DEVELOPMENT REVIEW COMMITTEE (DRC) COMMENT REPORT

PROJECT NAME: ArtsPark Lofts

CASE NUMBER: UDP-S22029

REQUEST: Site Plan Level II Review: 289 Multifamily Residential Units and 1,914 Square-Foot of Commercial Use in the Downtown Regional Activity Center

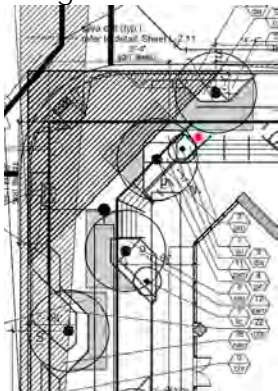
1. Preliminary Flood Insurance Rate Map shows property will become AE 6 flood zone.
The effective date of this change is not available at this time.
